From: Arnall, Guy
Sent: 01 August 2025 09:56
To: Webster, Ben (Planning Officer)
Subject: RE: Planning Consultation Request for case ref: 25/0538 (The Priory Hotel High Street Caerleon Newport NP18 1AG) (Planning Application)

Re: DETACHED BUILDING FOR USE AS OUTDOOR BAR (RETROSPECTIVE)

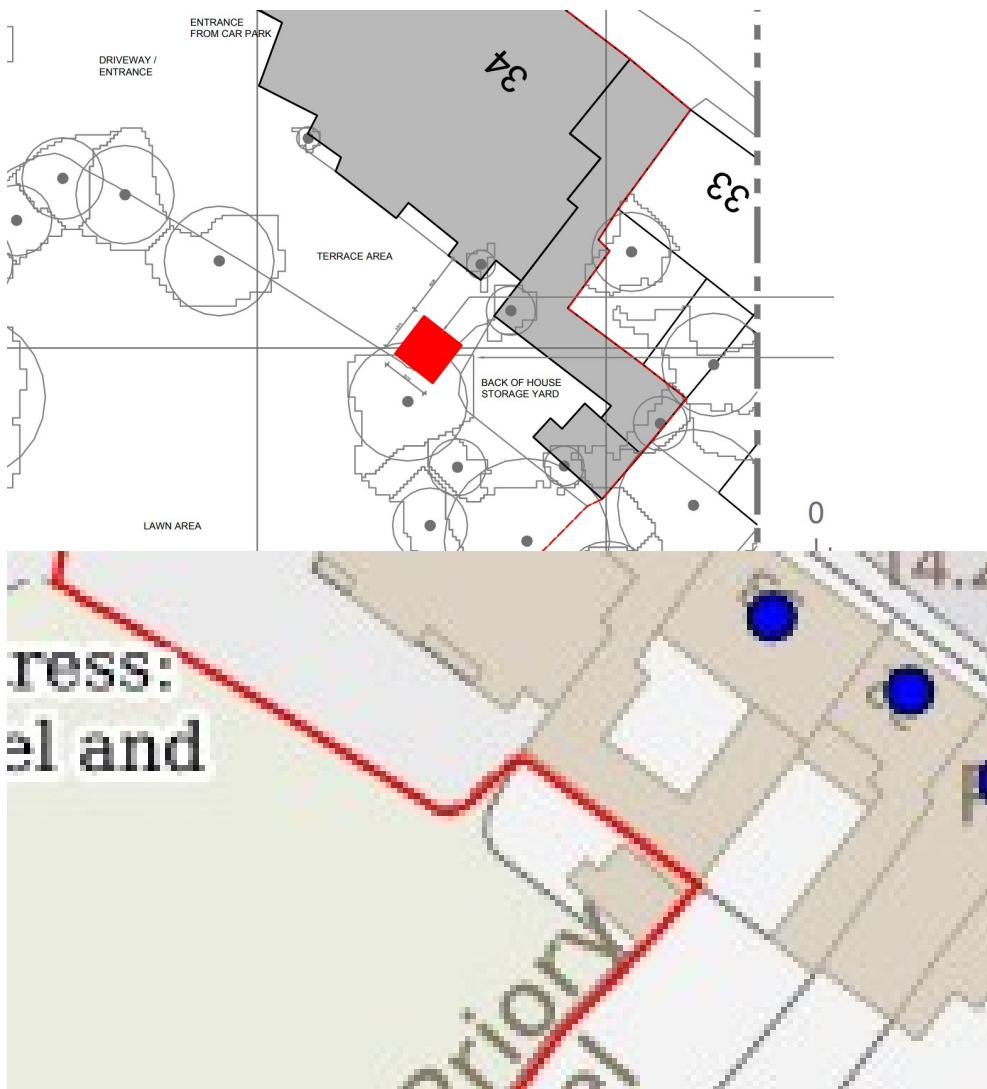
According to Cadw Map evidence, the north-eastern boundary of SM *Caerleon Legionary Fortress: Area between Priory Hotel and Priory Lodge* is contiguous with the hardstanding boundary to the rear of the asset (see below). Therefore, the proposed is considered to constitute development which has a direct physical impact on a scheduled monument and therefore Welsh Ministers (Cadw) should also be consulted upon the proposal.

The applicant may wish to check the precise location of the proposed (and relocate/amend plan if necessary). However please note that, irrespective of any small relocation Cadw must still be consulted as the development falls under the consultation requirement thresholds copied below:
